Third Preliminary Consultation
MONTGOMERY COUNTY HISTORIC PRESERVATION COMMISSION
STAFF REPORT

Address:	20 Philadelphia Ave., Takoma Park	Meeting Date:	12/2/2020
Resource:	Contributing Resource Takoma Park Historic District	Report Date:	11/25/2020
Applicant:	Marwan Hishmeh (Alan Kinney, Agent)	Public Notice:	11/18/2020
		Tax Credit:	N/A
Review:	3 rd Preliminary Consultation	Staff:	Michael Kyne
Case Number:	N/A

PROPOSAL: After-the-fact roof replacement, porch alterations, dormer additions, deck enclosure, and new deck construction

A-105

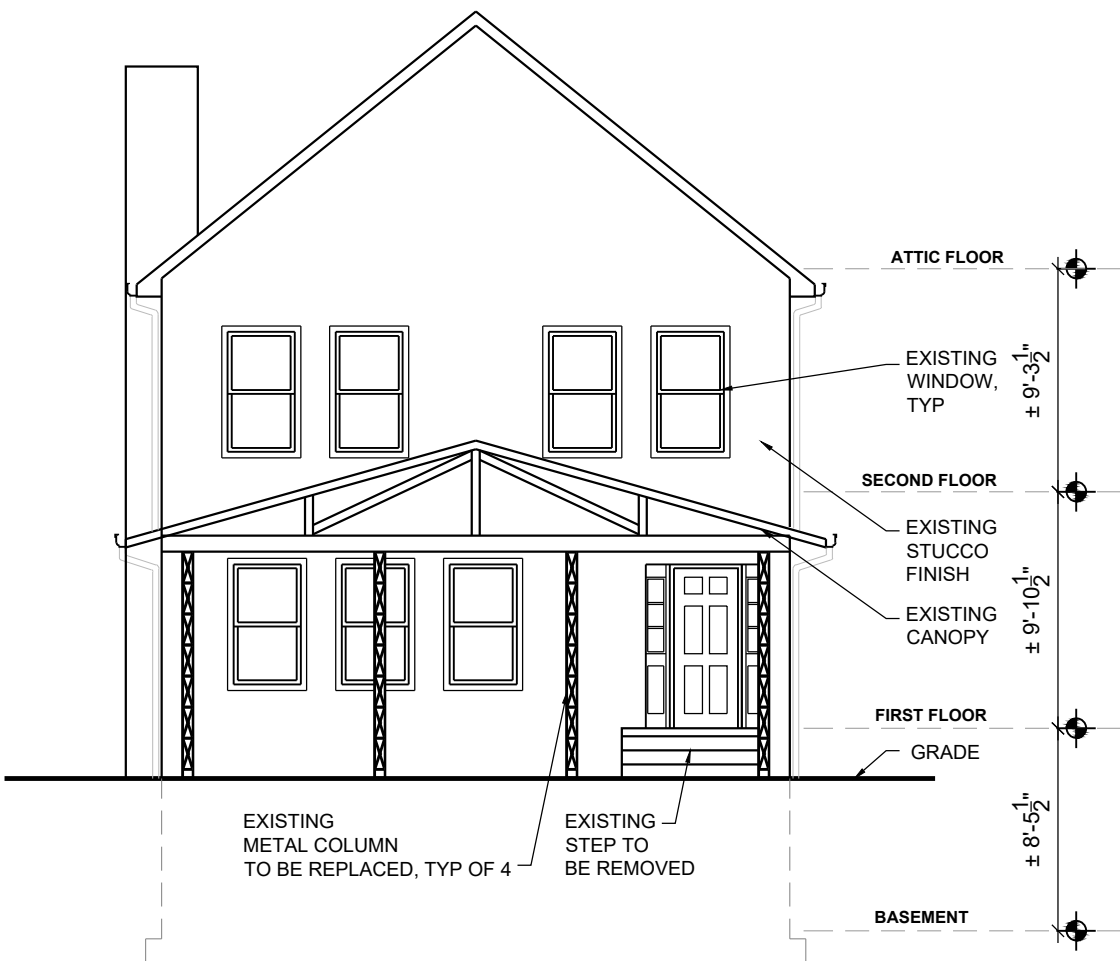
- Some Commissioners continued to recommend that the slate roof be replaced in-kind.
- One Commissioner specifically noted that the chimney on the northwest (right) side is not depicted in the floor plans, but it would likely prevent a matching dormer on the northwest roof slope. The chimney needs to be depicted in the plans.

Specifically, staff continues to seek the Commission's guidance regarding the proposed roof replacement. The issue for the Commission to consider is whether asphalt shingle roofing is an appropriate replacement for the slate roof, or should the slate roofing be replaced in-kind. Typically, a slate roof would be a character-defining feature of the resource. The *Guidelines* state that applicants "should preserve the predominant architectural features of the resource."
